UNITED STATES  
NUCLEAR REGULATORY COMMISSION  
WASHINGTON, D. C. 20555

SUBJECT: SAN ONOFRE 1 SEISMIC EVALUATION, STRENGTH  
OF COLUMN-TO-FOOTING CONNECTIONS IN NORTH  
TURBINE BUILDING EXTENSION

San Onofre #1 - North Turbine Extension

Investigation of Anchor Bolts for Columns

Column B-7

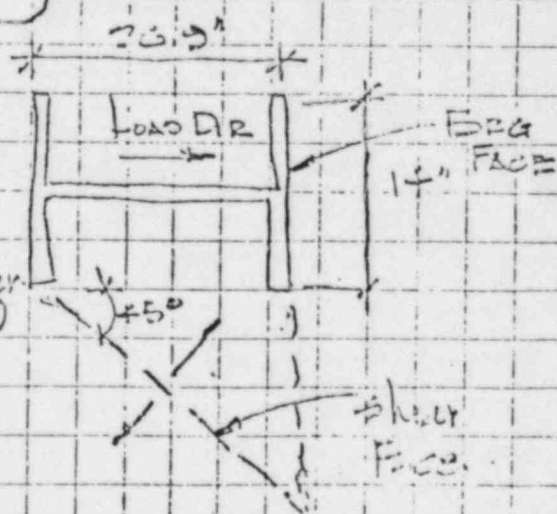
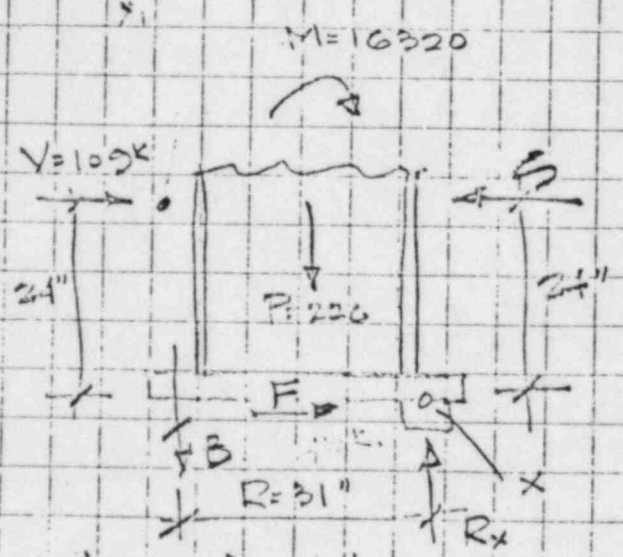
Max allowable shear stress  
 $= 4 \sqrt{4000} = 253 \text{ psi}$  (shear reinforcement not considered)

Max allowable shear load around column =  
 $2 \times 26.9 \times 1.42 \times 8 \times 0.253 = 153 \text{ k}$

Maximum Bearing Stress =  $0.35 \times 4000 = 3400$

Max Bearing Load  $3400 \times 14 \times 5 = 331$

Max Load in slab =  $153 + 331 = 536 \text{ k}$

Ultimate strain = 0.0025"  
 Say max allowable  $\epsilon_c = 2/3 \times 0.0025 = 0.0017$ "  
 $E_c = 57000 \sqrt{4000} = 3.61 \times 10^6 \text{ #/in}^2$

$\Delta = \frac{PL}{AE}$  so  $P_{MAX} = \frac{\Delta}{L} \cdot AE$

$= 0.002 (8 \times 14) (3.61 \times 10^3)$   
 $P_{MAX} = 808 \text{ k}$  - ESTIMATED CRUSHING LOAD OF SLAB BEHIND COL. FIG. - MINIMUM

MAX Bolt Load :  
 $109 \times 0.97 = 102 \text{ k/BOLT}$   
 $= 204 \text{ k on 2 BOLTS}$   
 $= F$

Load into slab -  $\sum M_x = 0$

$S = \frac{(109 \times 24 + 16320 - 226 \times 15.5 - 264 \times 31)}{24} = 330 \text{ k}$   
 330 < 536.0 k

( $\sum F_x = 0$ ) Therefore F Required =  $330 - 109 = 221 \text{ k}$

( $\sum F_y = 0$ )  $R_x = \frac{226}{2} + 204 = 317 \text{ k}$  Friction Force available =  $317 \times 0.5 = 159 \text{ k}$   
 = Bolt load

So about  $271 - 159 = 112 \text{ k}$  Must be taken in the concrete below slab.  
 Assume 10" available concrete parallel to plane of base plate  
 So shear resistance available in concrete =  $10 \times 144 \times 0.253 = 364 \text{ k}$  O.K. & therefore there is no shear needed from bolts.

SEB has performed a somewhat rough calculation (copy enclosed) to evaluate the column base connections. This indicates that the slab-on-ground can be considered to provide sufficient restraint for the column base connections based on the maximum loads postulated. Therefore, the adequacy of these connections should not be used as a basis for requiring immediate modifications to the Turbine Building structure.

# Column B-6

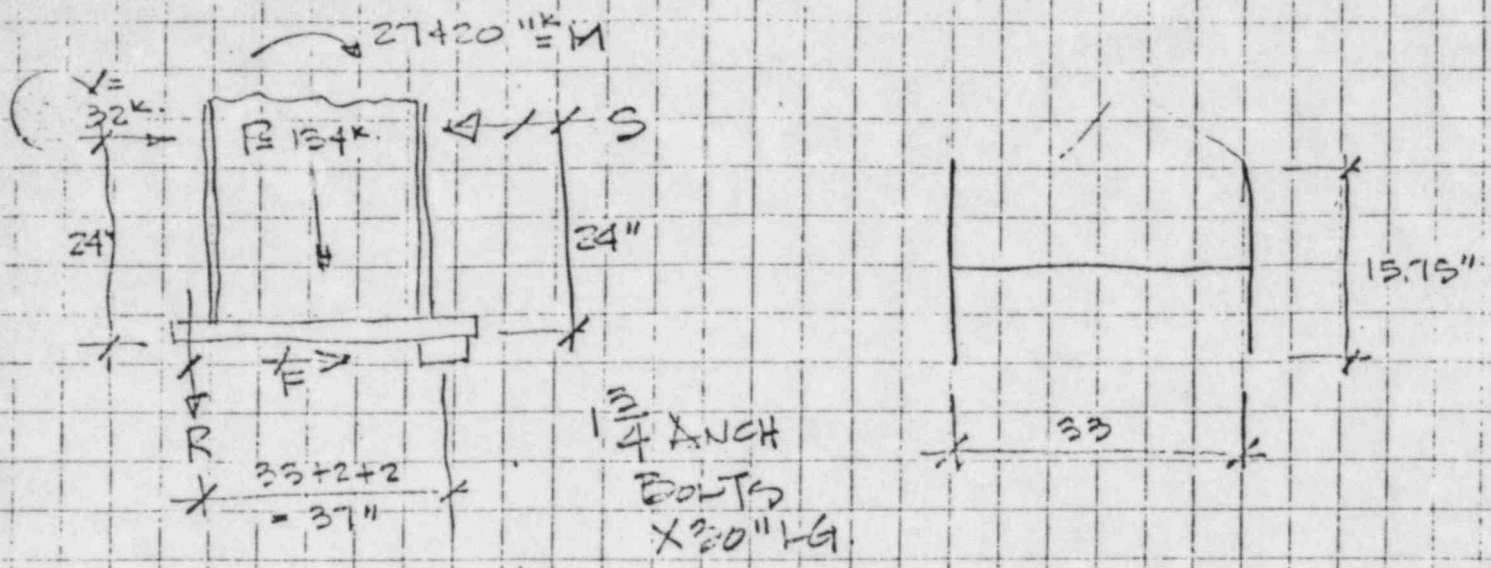
Shear -  $2 \times 3 \times 1.42 \times 3 \times 0.253 = 190k$   
 Bending -  $3.40 \times 15.75 \times 3 = 423k$   
 Max Slab Load =  $423 + 190 = 613k$  allowable.

$P_{max} @ 0.002 \text{ in/in Defl} = 0.002 \times 3 \times 15.75 \times 3.61 \times 10^3 = 910k$  Capacity at max strain

Max Bolt Load =  $19 \times 105 = 200k \therefore B = 400k$

$$S = \frac{(27420 + 132 \times 24 - 134 \times 15.5 - 400 \times 37)}{24} = 604k - 2k = 602k$$

$\sum F_x = 0 \quad F = 604 - 182 = 422k$  required  
 Friction Force =  $\frac{(134 - 400)}{2} (0.15) = 234k$  Bolt Load

$\therefore$  Need an additional resistance of  $422 - 234 = 188k$   
 From Concrete below slab. Shear resistance of  
 (say) 10" of concrete in plane of base plate =  $10 \times 4 \times 1 \times 3 = 364k >> 188$   $\therefore$  no shear needed from bolts.
